HIGHLAND COUNCIL

Committee: North Planning Applications Committee
Date: 7 December 2021
Report Title: 21/04244/FUL: Highland Housing Alliance
Phase 2, St Andrews Road, Dingwall
Report By: Acting Head of Development Management

Description: Application for landscaping, drainage and pathway design on land adjacent to St Andrews Road
Ward: 08 - Dingwall And Seaforth
Development category: Local
Reason referred to Committee: More than five objections

DRAWING No.
19001B_PL(90)003

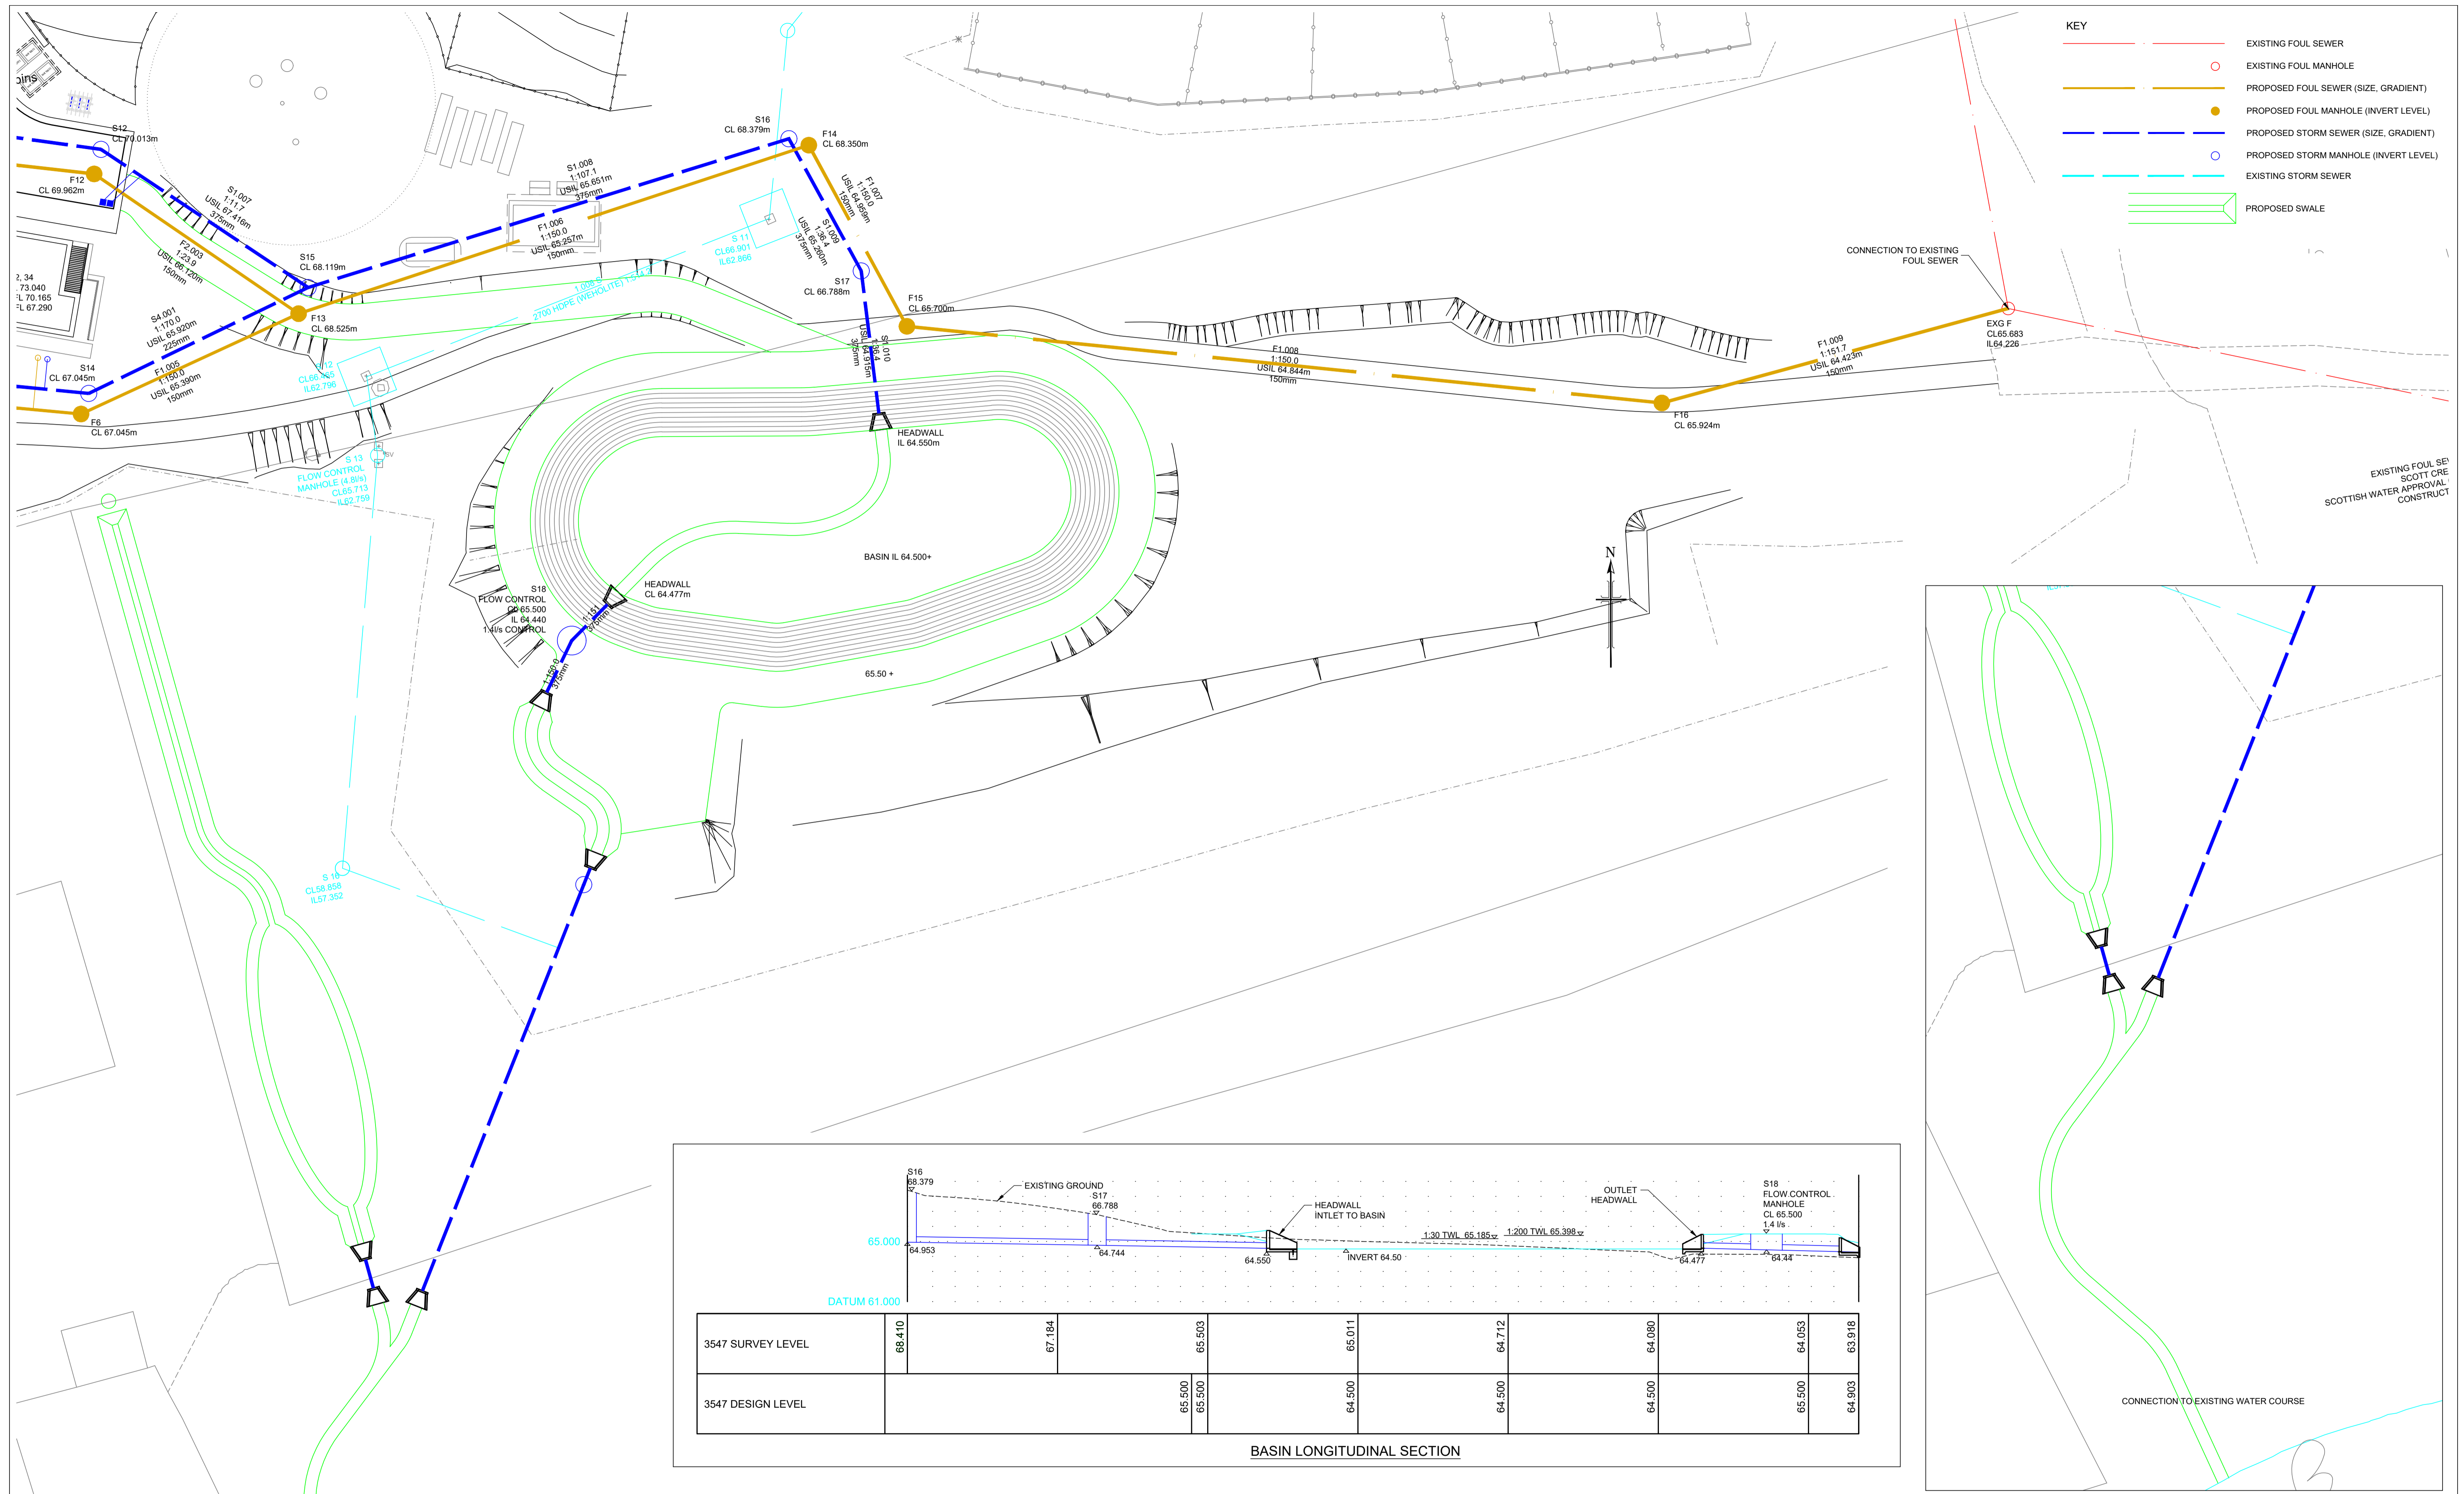
Surprisingly there does not appear to be a Landscape Plan submitted with this application. There is a Site Plan (Drg No. 19001B_PL(90)003) which shows indicative landscape proposals, but this lacks the detail and quality that is required for a Landscape Plan. As stated in Condition 16 of 20/03812/FUL, a maintenance schedule and details of a factoring arrangement are also required.

- Arboricultural Impact Assessment
- Tree Protection Plan and Arboricultural Method Statement
- Landscape Plan (this shall include:
 - the southern boundary of Plots 12-14 being pulled back from group of mature oak trees following the contour from the corner of the proposed turning head below Plot 11, around the north of the tree group and joining with the SW corner of 1 Macbeth Court.
 - landscaping features to break up the parking bays off the lower road
- Maintenance schedule
- Factoring arrangement

DRAINAGE LAYOUT SHEET 2 OF 2

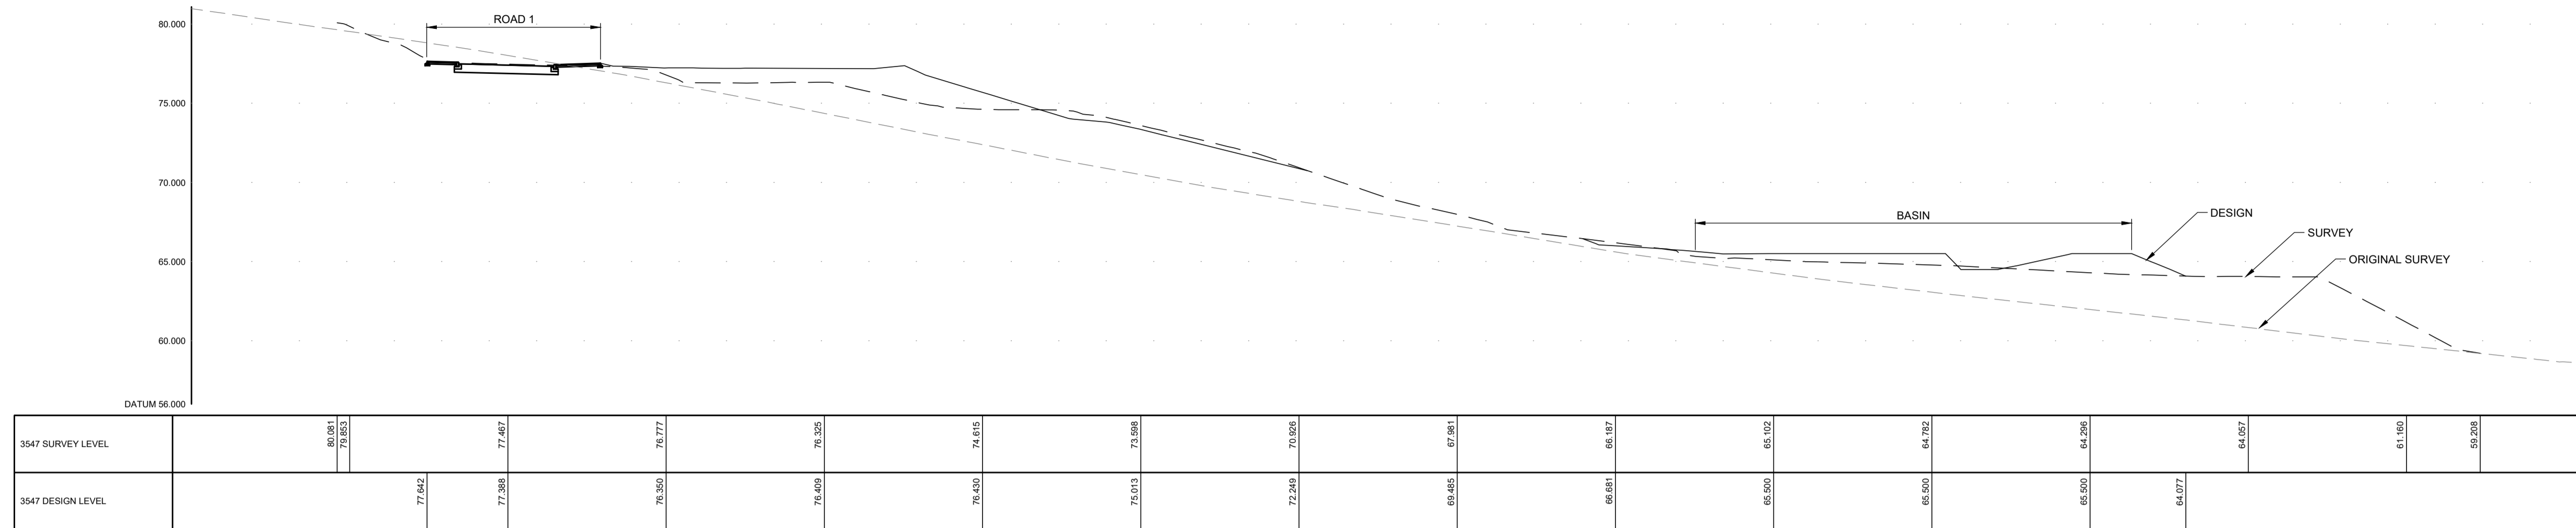
- The 'Full-Drainage-Layout-Sheel2_oC2-2488423.pdf expresses that the new area will be drained down into the existing watercourse. It also shows that the drainage of this new area will be connected to the existing area above. This will increase the catchment area much further than just the scope of the supplied works. The combined result will be a lot more water being fed into the "existing watercourse". The stream, identified as being the recipient of all the extra water flows directly under a property and chokes and overflows in storms and requires maintenance. It is expected that a considerably large volume of water can be drained into this already congested pipe with no thought to upgrading the existing groundworks to protect existing homes from flooding. SEPA maps show this waterway is a flood risk for 10 homes and goes into the corner of the primary school grounds. The development does have potential to increase flood risk elsewhere.
